MOOLARBEN COAL COMPLEX
UG1 OPTIMISATION MODIFICATION
RESPONSE TO SUBMISSIONS

7 SEPTEMBER 2015
Project No. MCM-14-05
Document No. 00689205

FIGURE 1

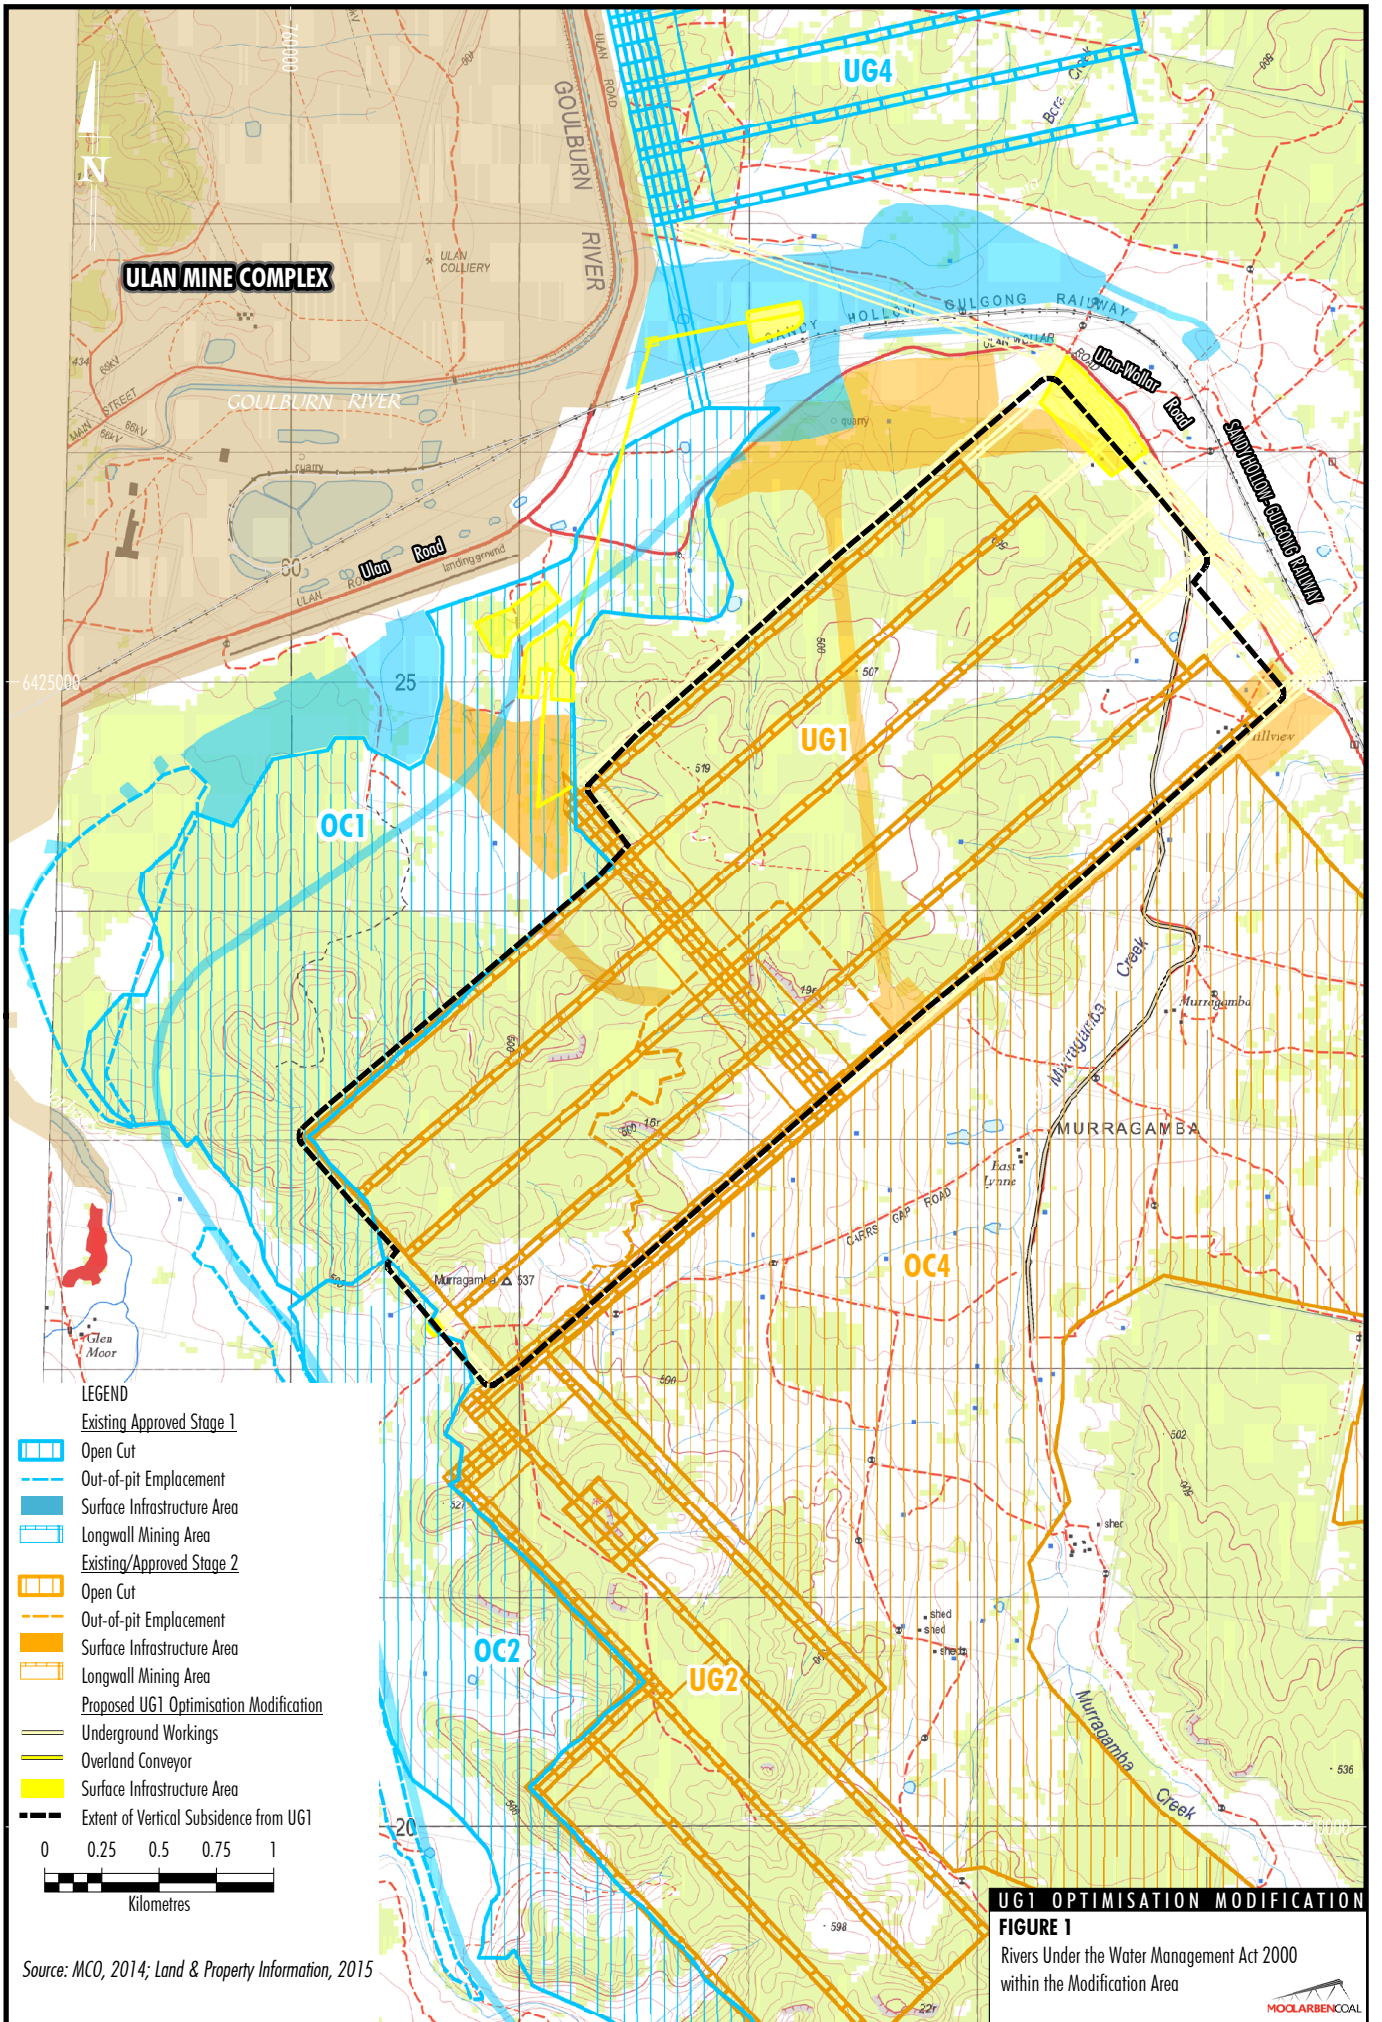
<p>DPI Water requested further information on the location of rivers as defined under the <i>Water Management Act, 2000</i>.</p>	<p>All watercourses shown on the 1:25,000 topographic map (i.e. rivers as defined under the <i>Water Management Act, 2000</i>) within the UG1 extent are shown on Figure 1 - enclosed.</p> <p>All of the rivers fall within the definition of a minor stream (i.e. are less than third order under the Strahler stream order system as determined from the published 1:25,000 scale topographic map of the area).</p>
